**TOWN OF MOUNTAIN VILLAGE
REGULAR DESIGN REVIEW BOARD MEETING
AGENDA**

THURSDAY MARCH 25, 2021 10:00 AM

TO: Mountain Village Design Review Board
FROM: John Miller, Senior Planner
FOR: Design Review Board Public Hearing; March 25, 2021
DATE: March 15, 2021
RE: Staff Memo – Final Architecture Review, Lot 434

2 SITE PLAN MAXIMUM HEIGHTS

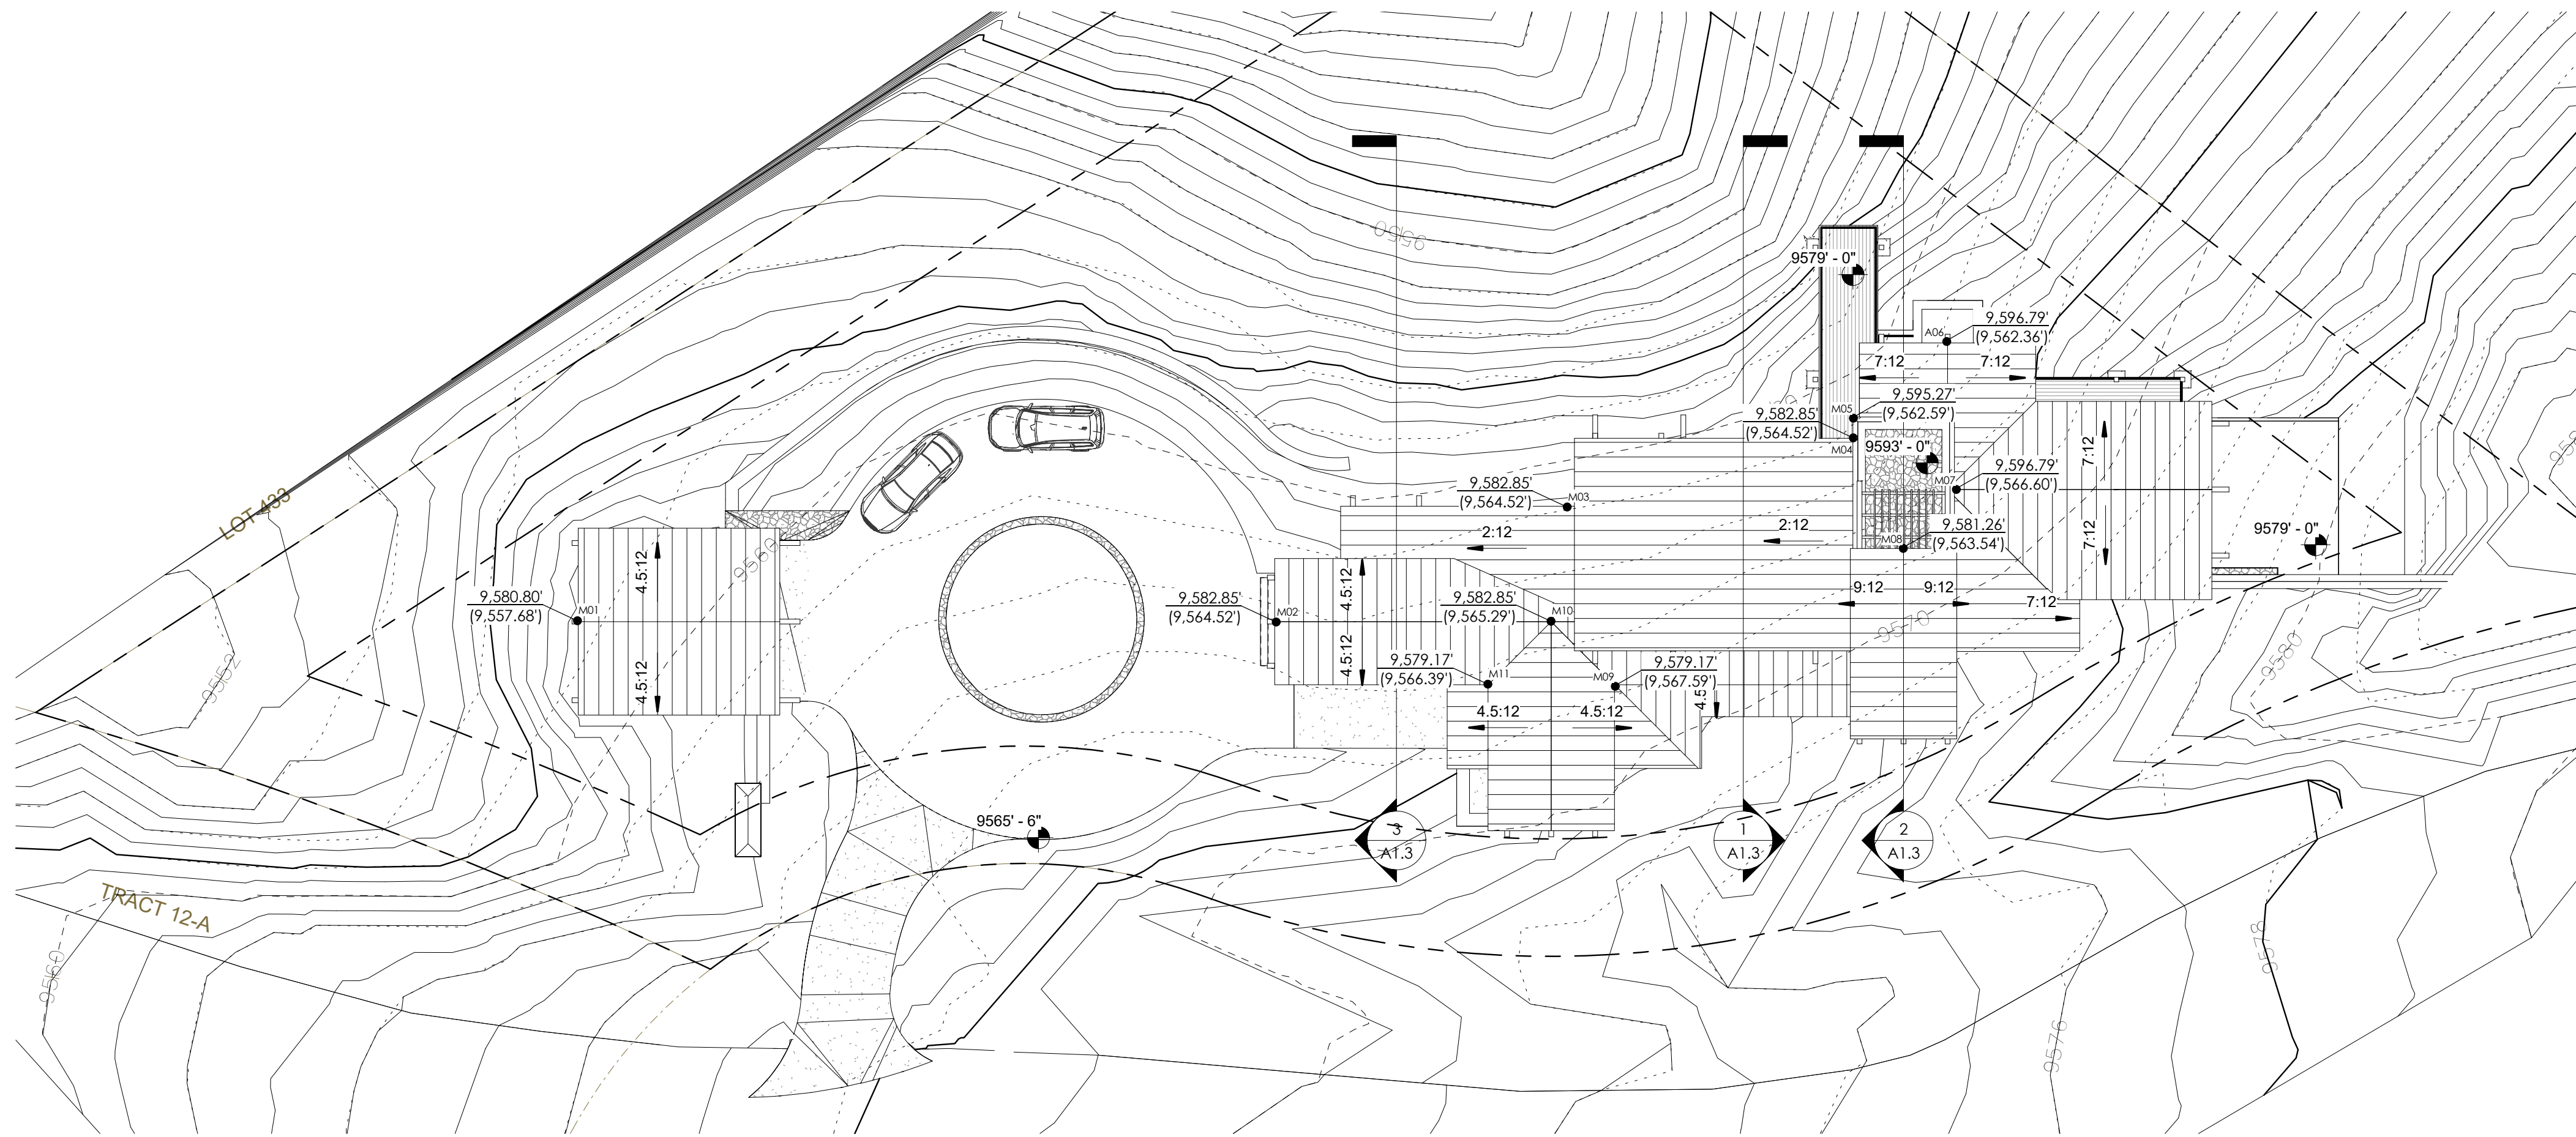
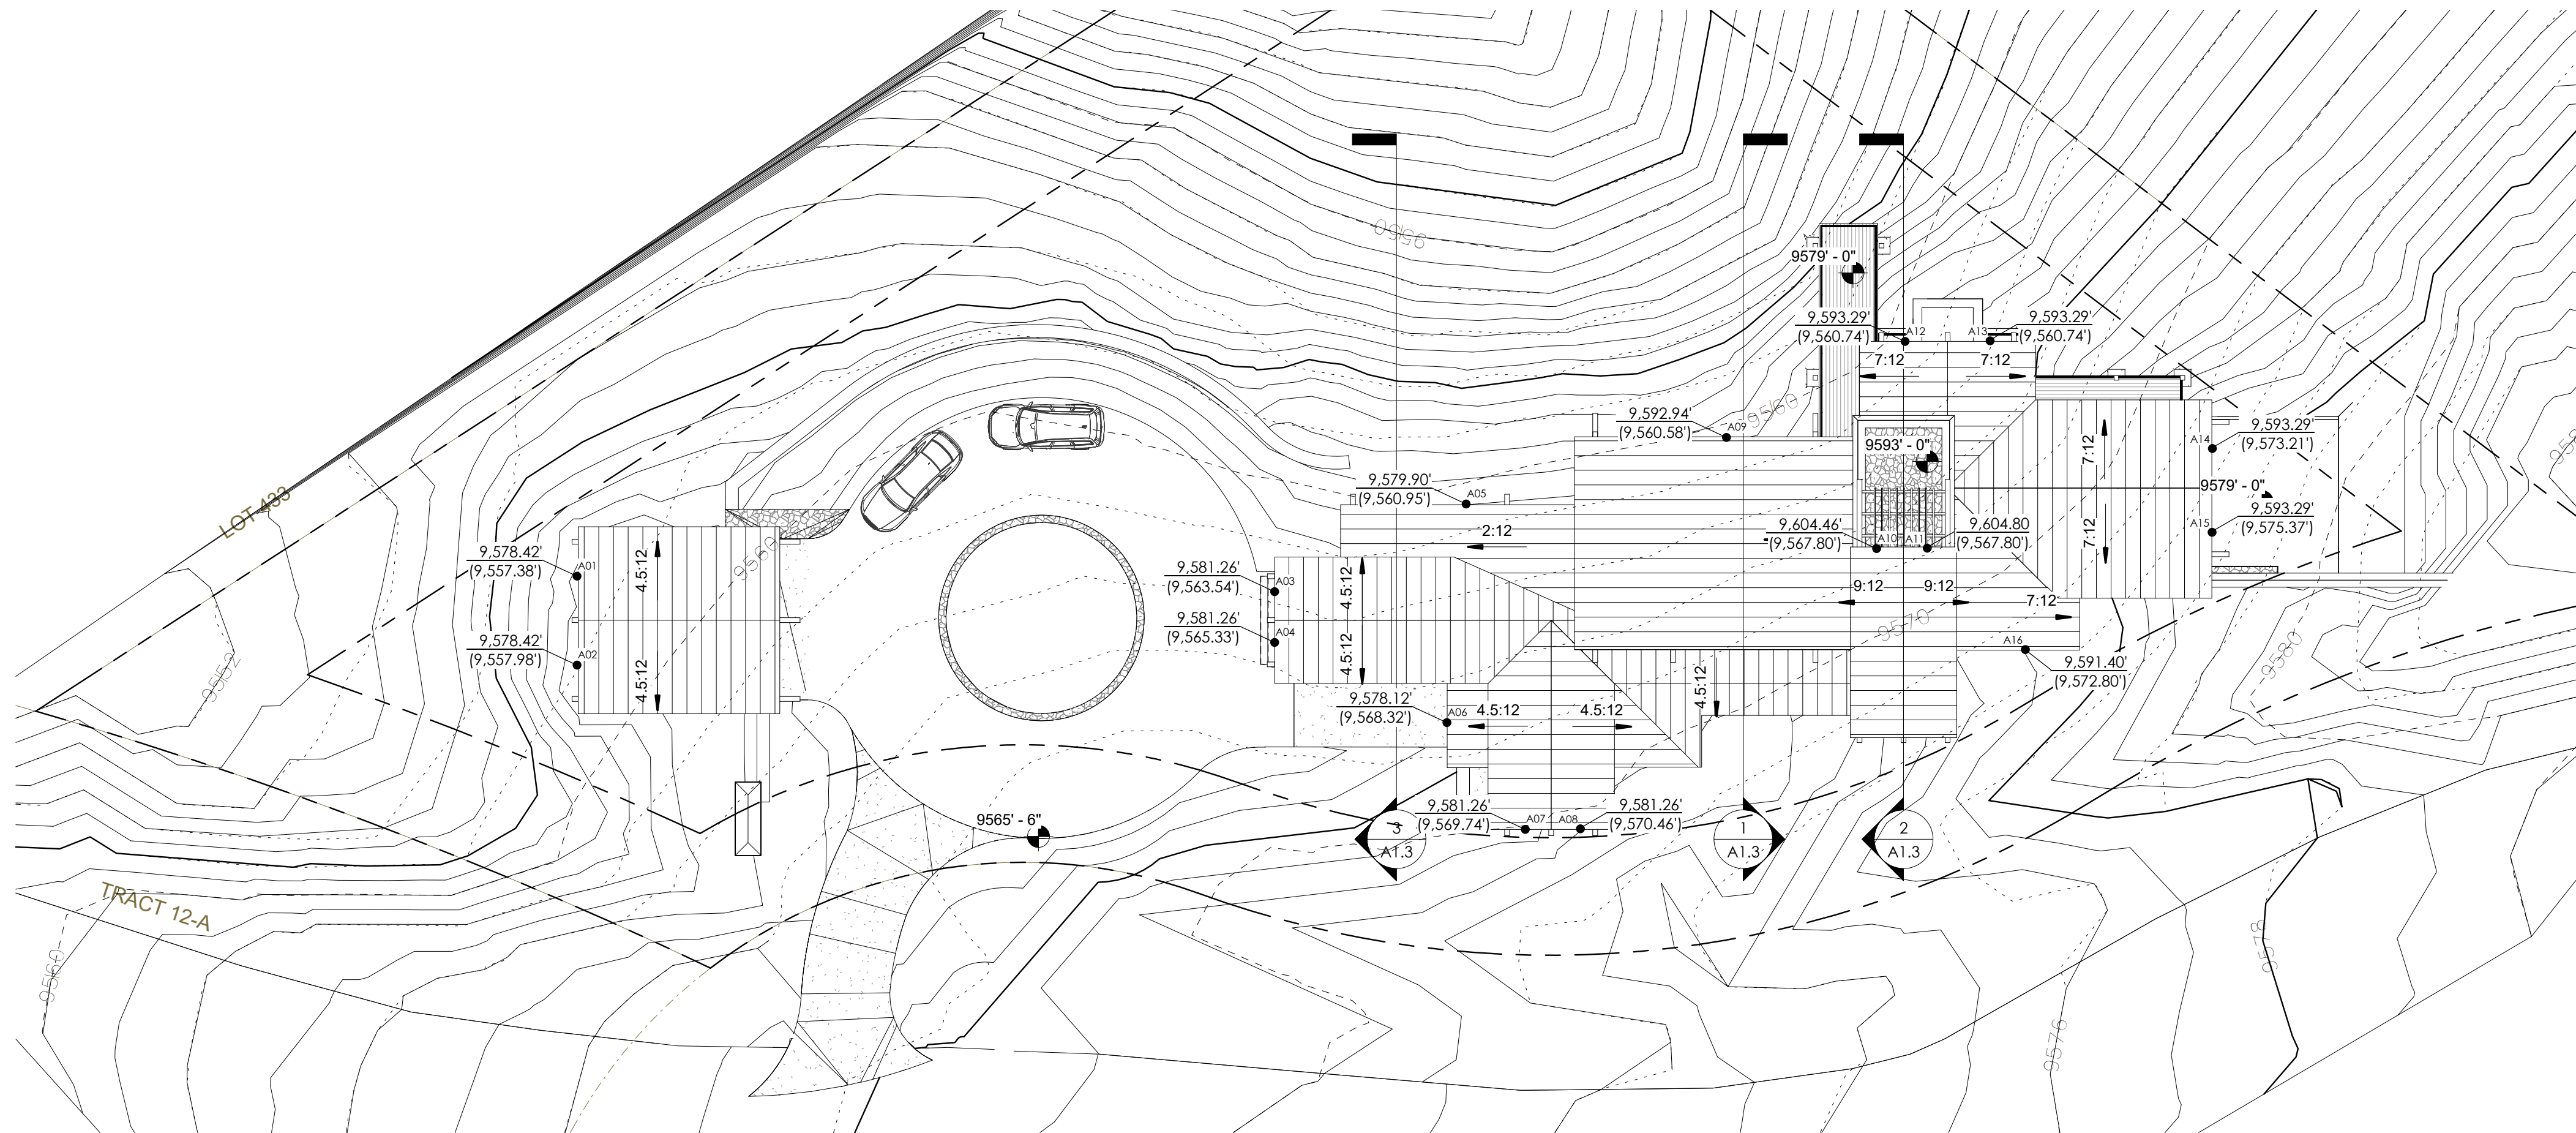
Staff: As part of this application, the applicant has provided both a Maximum Building Height and Average Building Height analysis. Based on the heights provided, the applicant is 39.68 feet from the highest ridge to the grade below on the gabled portion of the home. Additionally, the applicant has provided a parallel plane analysis demonstrating that no portion of any shed roof forms penetrates the 35-foot parallel slope height allowance.

1 MAIN LEVEL LIGHTING PLAN
LT1.20 SCALE: 1/4"=1'-0"

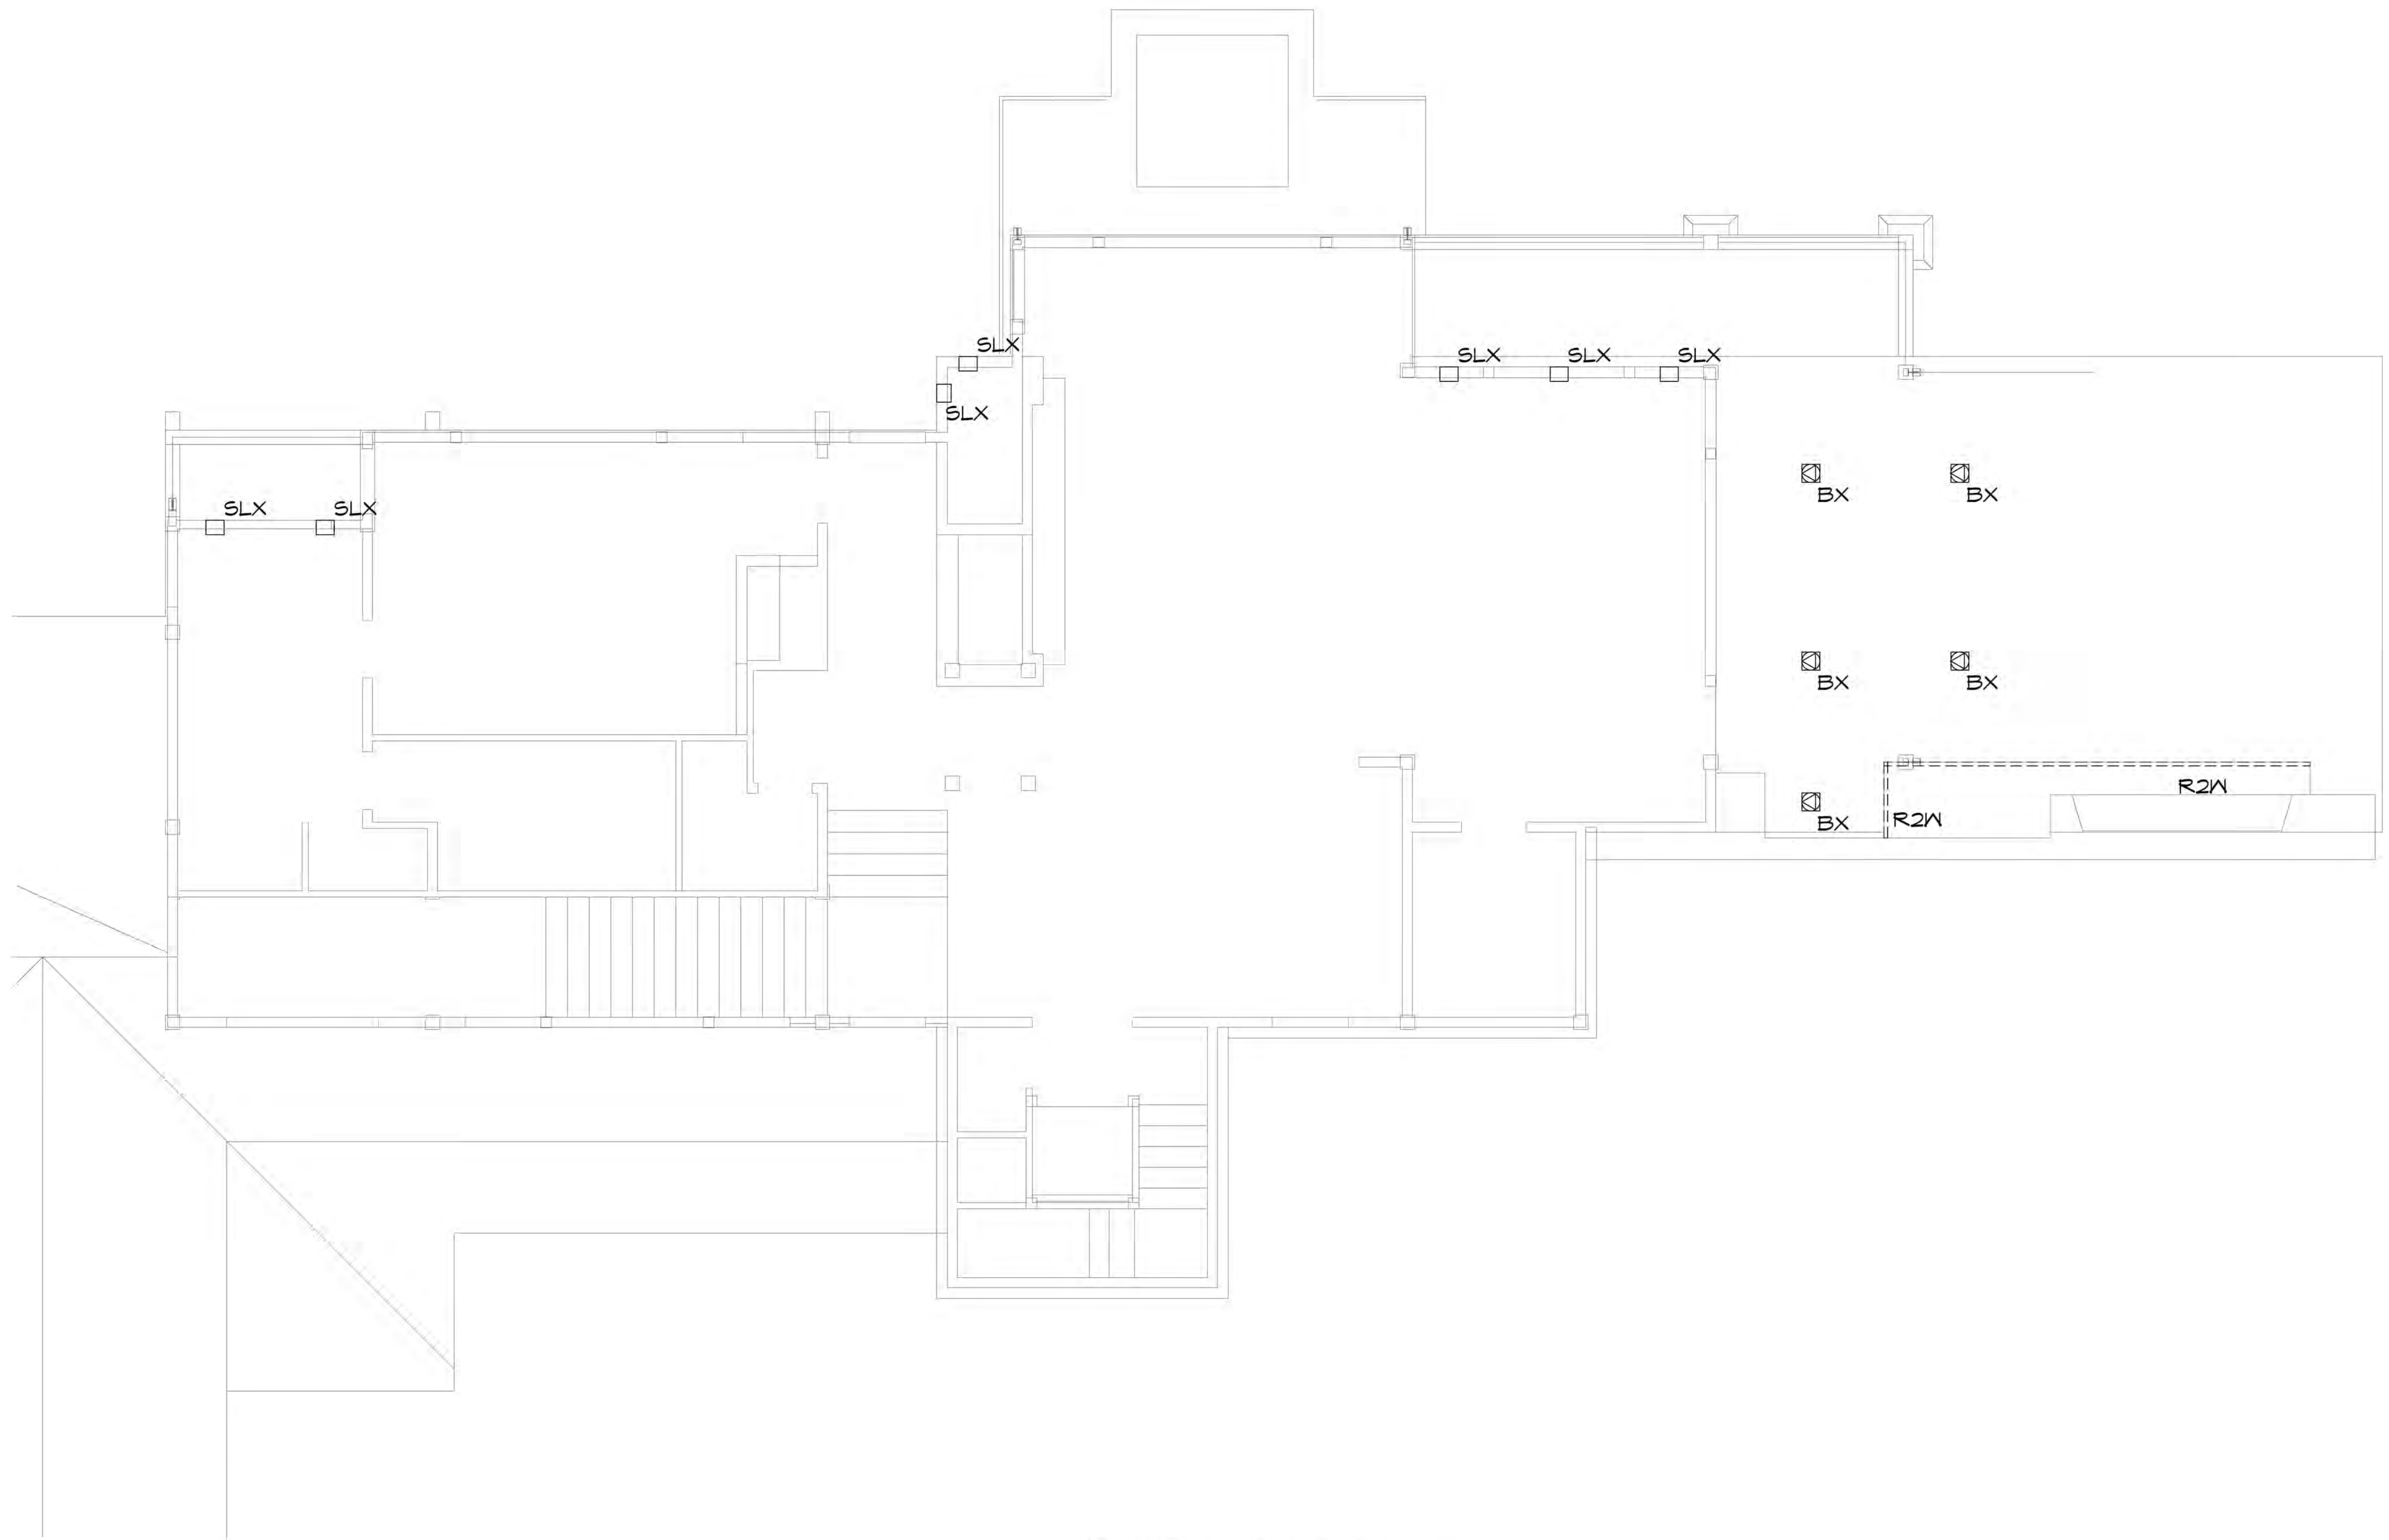
Staff: The applicant has provided an updated lighting plan for final review. Staff does not believe the fixtures labeled BX and XD1 meet the requirements of the CDC. BX appears to exceed the total maximum lumen requirements, and XD1 does not appear to be a downlit shielded fixture. Prior to the issuance of a building permit, the applicant shall work with a member of staff and DRB to provide a lighting plan that meets the requirements of the CDC. The applicant did provide an updated photometric study for the Lot and based off this; it appears that there will be no light trespass on adjacent properties – meeting the requirements of the CDC.

- 3) Prior to submittal for building permit, the applicant shall revise the lighting plan fixtures BX and XD1, and shall obtain approval from Town Staff and a Member of the DRB.
